1.0 Noise effects of development on land to west of A1(M) and south of Stevenage Road, Todds Green Heading 2

1.2 We have been asked by Stevenage Borough Council to independently assess using noise prediction software, the effects of the new development and especially its roadside barrier upon existing dwellings to the east of the A1M where people have complained of increased noise.

Noise Map 1 - CadnaA Ground Floor Historical CRTN method – No barrier or development.

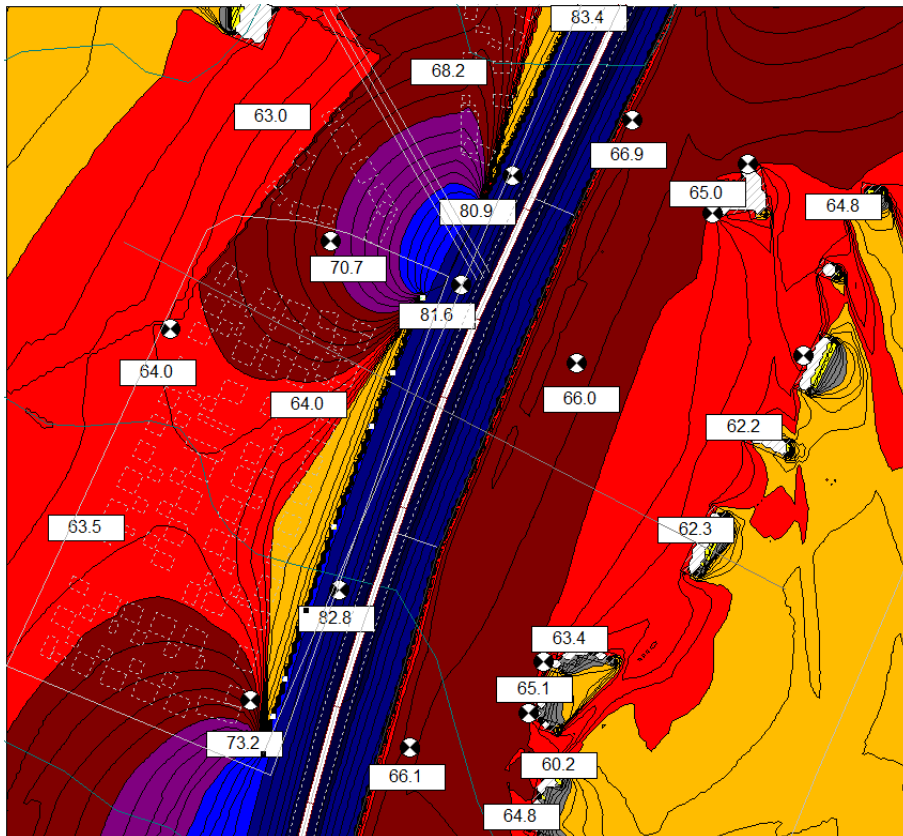
- 2.15 The figures in the rectangular boxes are receiver noise levels at some of the nearest buildings. The only change between one noise map and the second is the presence or absence of the new barrier.

- 2.16 It can be seen using the CRTN procedures as mandated by UK Government as the method of predicting and assessing road traffic noise impact, the introduction of the barrier results in a difference between 0.2-1.1dBA at buildings on the eastern side of the A1M. This change would be considered generally as not identifiable by people with normal reasonable hearing when ignoring spectrum change.

Noise Map 2 - CadnaA Ground Floor – CRTN method with barrier - Ground Floor range of differences using CRTN = 0.3-1.1dBA.

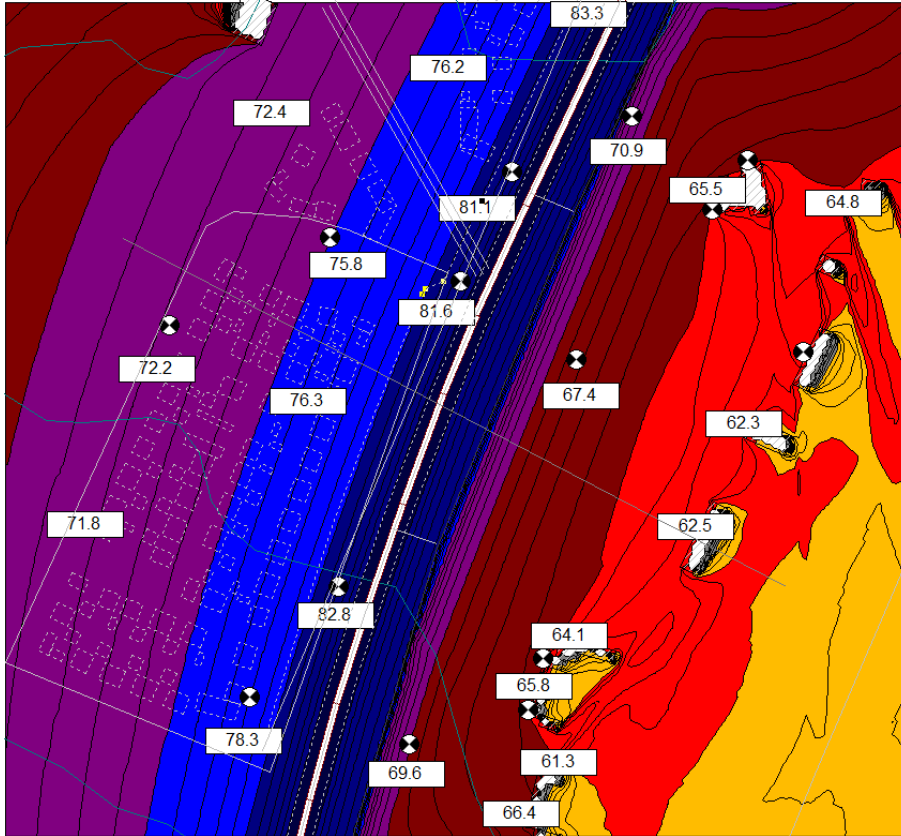
- 2.17 This change is a greater change than identified by the developer's acoustician but this arises due to a range of concerns over the inputs into their model which are considered to place their results further from reality than the MAS model here. It is also possible there are some limitations within Sound Plan that does not appear to follow CRTN precisely. Notwithstanding the differences both methods do not indicate a significant change and the use of this model to predict the benefits of the barrier at the new development are not overly of concern.

Noise Map 5 – Shows 1.5m changes in decibel levels caused by introducing the development 8/4/8m barrier. There are significant reductions to the west of the barrier and slight increases to the east but which approach a 3dBA between some buildings further from the road. Contours are 1 decibel apart

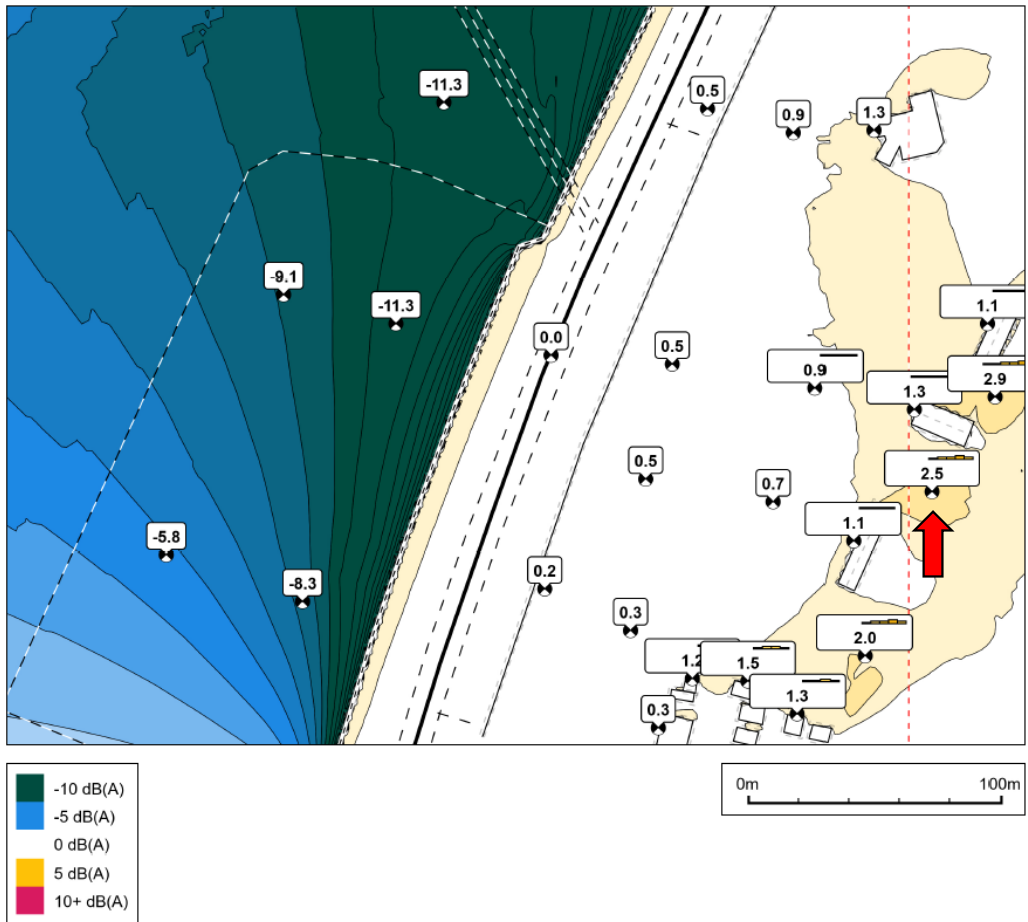
- 2.31 Noise map 5 shows the difference at ground level (1.5m agl) but at receiver points (values in rectangular boxes) a more detailed set of differences are provided. These include the level at 4.5m (first floor level) and the difference in spectrum levels. These are reproduced in the table below.

- 2.32 It can be seen from Noise Map 5 that the ‘A’ weighted level now ranges 0.3-1.5dBA at ground floor level of those locations closest the road. At first floor level this ranges 0.4-1.7dBA. The true values will depend on the reflectivity of the barrier and the buildings but in any event it can be seen there is a greater change using this method than the UK Government method.

- 2.33 What is noted is that between some buildings further from the road, even with low coefficients of reflection, there is a greater change approaching 3dBA (see red arrow). This is a noticeable change regardless of the spectrum change and

it reflects a perceptible change in a general sense. The true extent of this is almost impossible to predict due to the limitations of modelling and the precise differences in the buildings and their reflectivity. It is therefore indicative only. For example all buildings are assumed as 8m high and not with walls to around 6m and with a sloping roof on top of that. Adjustment for sloping roofs could be created but this is a further uncertainty. In any event the greater change which will be noticed is in terms of the character and spectrum of the noise. This is assessed further below.

Figure 1 – Levels at Receiver location24 show most noise in the 1KHz band followed by the 500Hz band then 2KHz band and 250Hz band then 125Hz band before 4KHz. The lowest band is 8KHz at 30dB below the 1KHz band and so effectively masked.

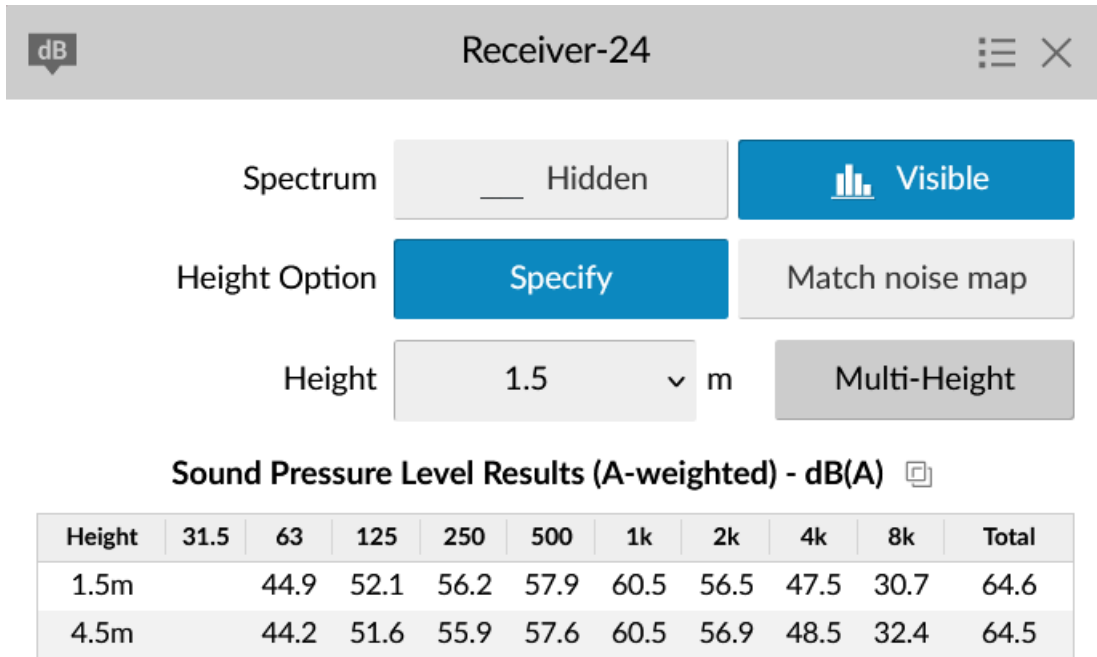
2.40 The extract below (Figure 1) from the modelling shows the resulting levels at the worst case location rather than the change in levels for 1.5 and 4.5m heights. It can be seen the 4KHz and 8KHz sound energy bands contribute much less sound energy and the 2KHz band is also behind the 500Hz band.

2.41 Thus increases in sound in higher frequencies will introduce slight change but unless within about 10-15dBA of the highest values making up the noise it will not be readily perceptible. In the example above, in Figure 1 (compare the table and chart below for Receiver 24) the change at 4KHz and 8KHz will not be noticeable despite their size but the 4dB change at 1KHz will be observed as it is the dominant ‘A’ weighted value. The 2KHz value change might just be identified and change character noticeable but they happen simultaneously.

Chart 1 – Shows change in levels at receptor locations due to barrier introduction.

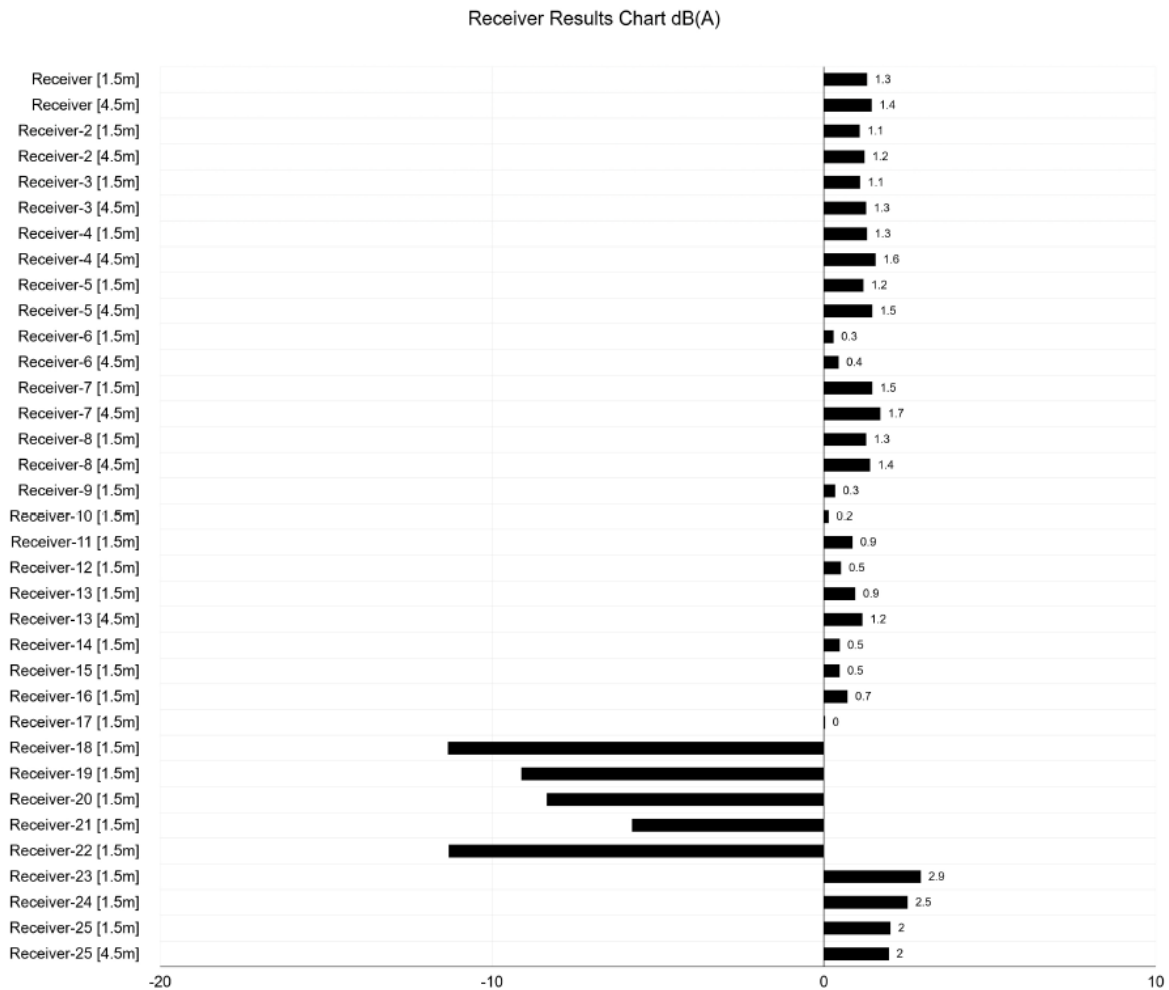
2.42 Receiver locations 23-25 are between buildings in the open and reflect a slightly greater change with a ground floor level change of 2.9dBA. This would be noticeable without any change in the spectrum or character of the noise. However there is also a spectrum shift with a significant change in the region of 1KHz-8KHz. As before the 4-8KHz contribution is well below other bands. The combined spectrum shift and overall ‘A’ weighted decibel level rise would be

distinct and recognisable where it is within 10-15dBA of the total noise. The main factor is the spectrum change of octave bands that are the main contributor to overall levels such as 1KHz meaning the road traffic noise would sound as if less screened by the existing mound or as if the existing mound no longer existed.

2.43 The mid frequency noise continues to dominate the resulting road traffic noise at the dwellings to the east of the A1M even with the extra higher frequency noise but the 1KHz band dominates much of the sound and this band is increased as well as the higher frequencies. The latter is less noticeable as they are well below overall levels and so masked better.
